CITY OF MILWAUKIE

DESIGN AND LANDMARKS COMMITTEE

5.1 Design review meeting for DR-2021-003 (Kellogg Bowl/Henley Place, 10306 SE Main St)
Staff Person: Brett Kelper, Associate Planner

Thank you for your review of the Henley Place multifamily project and deeming the application complete. This letter is in response to the “approvability items” noted in your letter dated June 15, 2021. The comments are shown in *italics*, with the Applicant’s response directly below.

C22

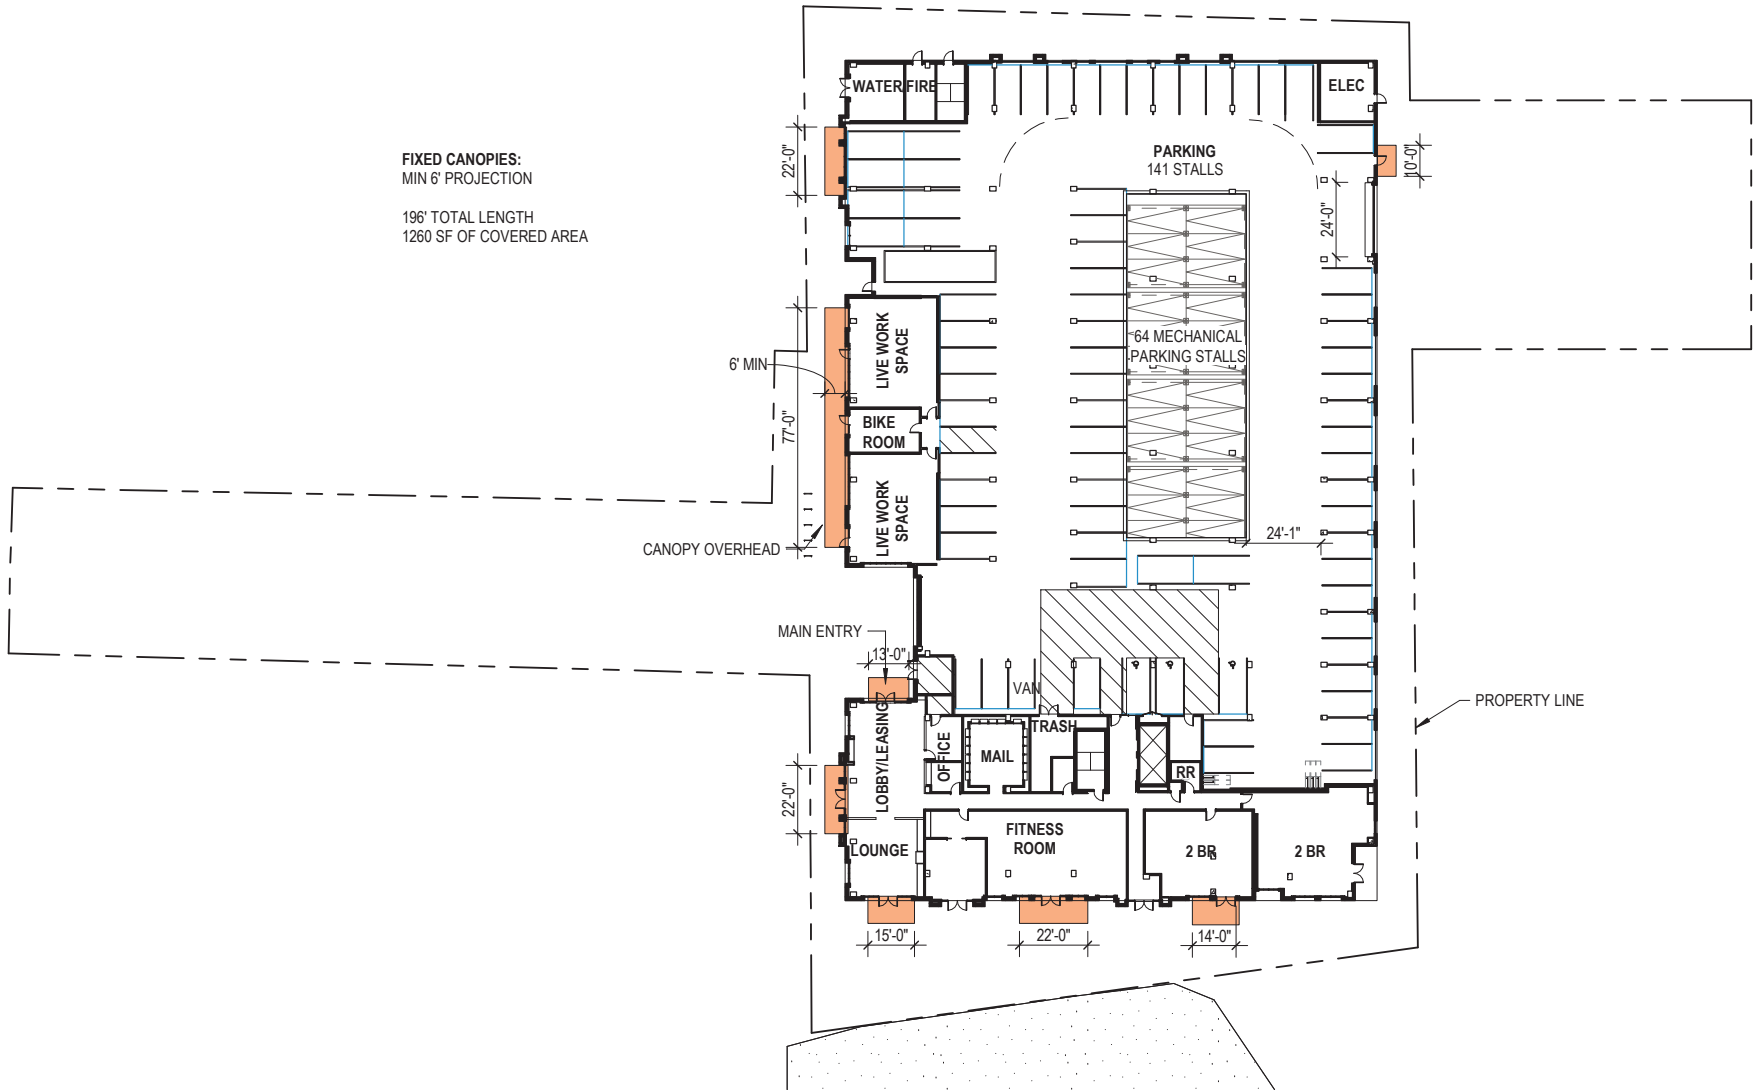
- (1) *As per MMC Subsection 19.508.4.C.2.a(1), weather protection is required for all ground-floor building entries. Looking at Sheet C-24, it appears there are some entries on or near the south side of the building that are not covered. This includes the entries into the two-bedroom unit at the southeast corner of the building, on both the south and east elevations.*

Response: The plan sheets have been checked and updated for consistency. Weather protection canopies are provided over the public building entries on the west, south and east sides of the building. Some weather canopies are provided over private residential units for aesthetic purposes. Canopies are not provided over all private unit patio doors. Sheet C24 entitled “MMC 19.508.4.C.2 Weather Protection” is the guiding sheet for weather canopy information.

FIXED CANOPIES:
 MIN 6' PROJECTION
 196' TOTAL LENGTH
 1260 SF OF COVERED AREA

EAST ELEVATION

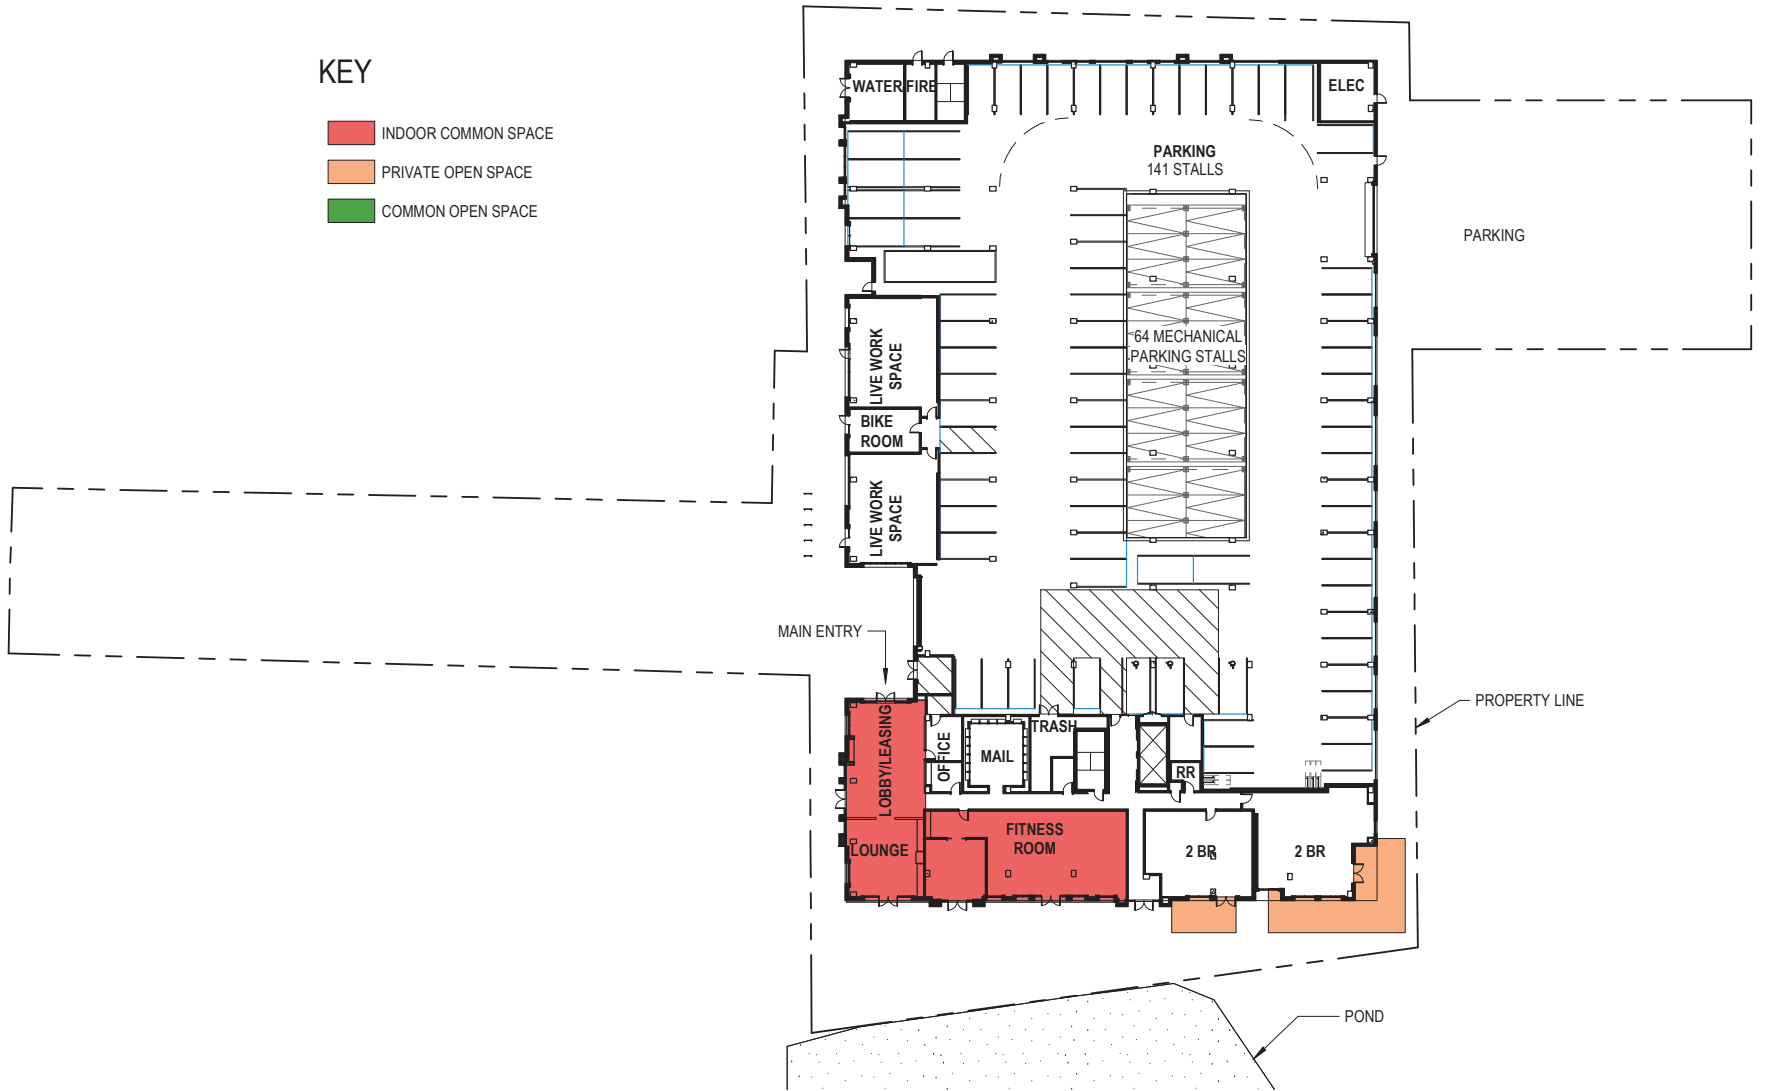
As noted above, the eastern façade (facing 23rd Avenue) is considered street-facing and is therefore subject to the standard for 40% ground-floor windows, which it appears to meet. However, it is not clear that the eastern façade meets the 30% glazing standard for upper floors. Please provide additional information sufficient to demonstrate that this standard is met or discuss how the design is substantially consistent with the purpose statement of this design element and any applicable downtown design guidelines.

Response: The plans have been updated to provide wall openings and glazing area calculations for the west and east facing façades. Please refer to plan sheets C25 and C26.

GROUND FLOOR WALL AREA = 3240 SF
GROUND FLOOR OPENINGS = 1691 SF (=52%) - MIN 40% OPENINGS REQUIRED

WEST ELEVATION

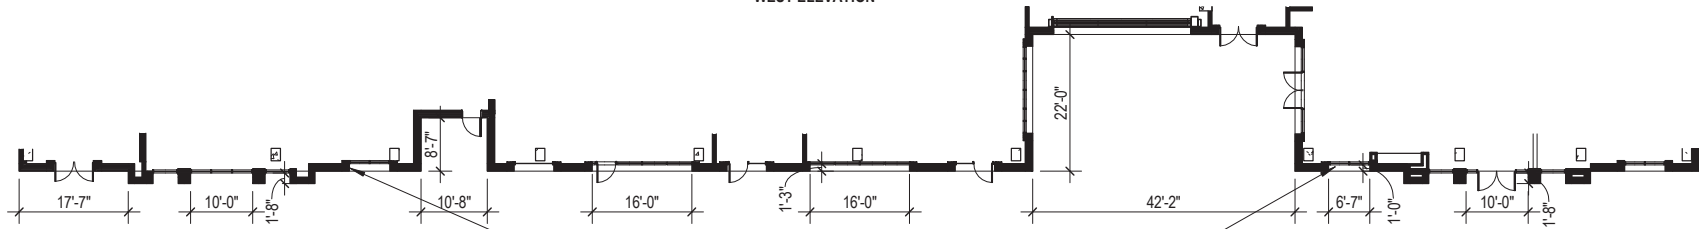
- (2) *Exterior wall off-sets—It is not clear from the plan sheets that horizontal off-sets are provided at 40-ft intervals along the entire length of the primary façade (west elevation) on the ground-floor level. Please confirm whether the aluminum storefront windows along the 80-plus-ft façade of the live/workunits are intended to serve the offset function.*

Response: A partial cross section of the west building façade at the ground floor has been added below the elevation view on sheet C33, which demonstrates that the architectural design provides the required exterior wall off-sets.

MINIMUM 12" OFFSET
EVERY 40' OF FACADE
